# UNITED STATES PATENT AND TRADEMARK OFFICE

APPLICATION NO.	FILING DATE	FIRST NAMED INVENTOR	ATTORNEY DOCKET NO.	CONFIRMATION NO.
10/731,950	12/10/2003	Woong-Kwon Kim	10125/4132	6763

<b>Office Action Summary</b>	<b>Application No.</b> 10/731,950	<b>Applicant(s)</b> KIM ET AL.	
	<b>Examiner</b> HOAN C. NGUYEN	<b>Art Unit</b> 2871

## DETAILED ACTION

FIG. 2

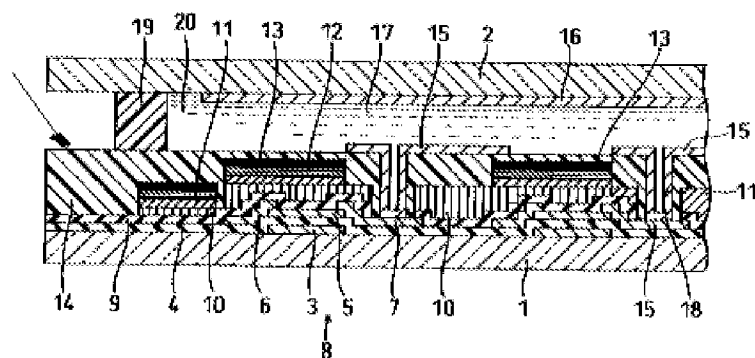
- thickness of the light-shielding color filter patterns is equal to or less than a thickness of the color filter.
- a top surface of the color filter substantially has the same level as a top surface of the light-shielding color filter patterns since the top surfaces of the color filter and light-shielding color filter patterns is the surface of the flattening film 14.

top surface of color filters and top surface of light-shielding color filters pattern are the same
